SUBJECT: COMANCHE PEAK NUCLEAR POWER PLANT, UNITS 3 AND 4
DOCKET NUMBERS 52-034 AND 52-035
RESPONSE TO REQUESTS FOR ADDITIONAL INFORMATION
NO. 2748, 2764, 2843, 2844, 2875, AND 3400

Response to Request for Additional Information No. 2748 (CP RAI #35)

RAI NO.: 2748 (CP RAI #35)

Figure 11.3-201 Gaseous Waste Management System Piping and Instrumentation Diagram (Sheet 3 of 3)

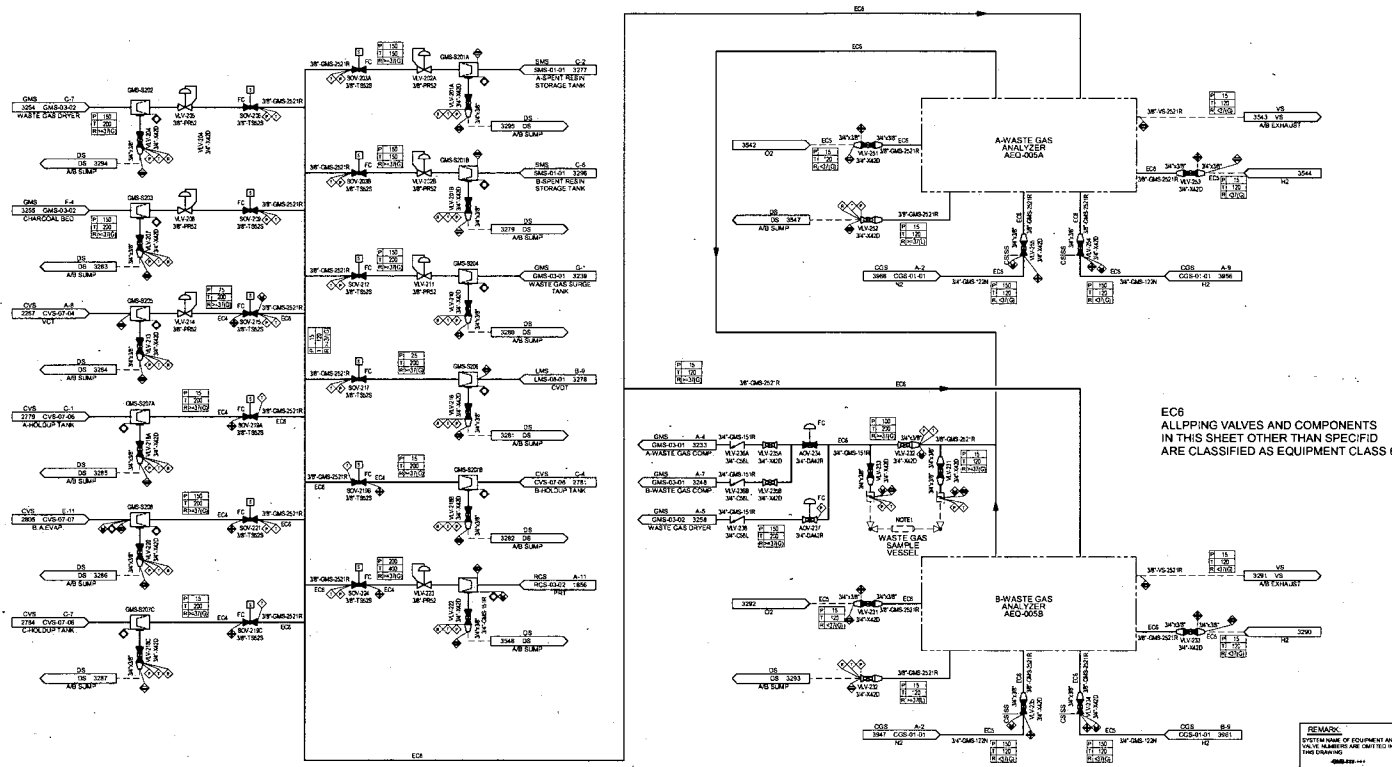
Regulatory Position 2.3 of Regulatory Guide 1.143, "Design Guidance for Radioactive Waste Management Systems, Structures, and Components Installed in Light-Water-Cooled Nuclear Power Plants," Revision 2, November 2001, states, "The portions of the gaseous radwaste treatment system that are intended to store or delay the release of gaseous radioactive waste, including portions of structures housing these systems, should be classified as described in Regulatory Position 5 and designed in accordance with Regulatory Position 6." Luminant is requested to explain why Combined License Application, FSAR Figure 11.3-201 Sheet 3 does not include the same note as Sheets 2 and 3, which states, "All piping valves and components in this sheet other than specified are classified as equipment class 6."

The note contained in FSAR Figure 11.3-201 Sheets 1 and 2, which states, "All piping valves and components in this sheet other than specified are classified as equipment class 6," has been added to Sheet 3.

EC6
 ALL PIPING VALVES AND COMPONENTS
 IN THIS SHEET OTHER THAN SPECIFIC
 ARE CLASSIFIED AS EQUIPMENT CLASS 6.
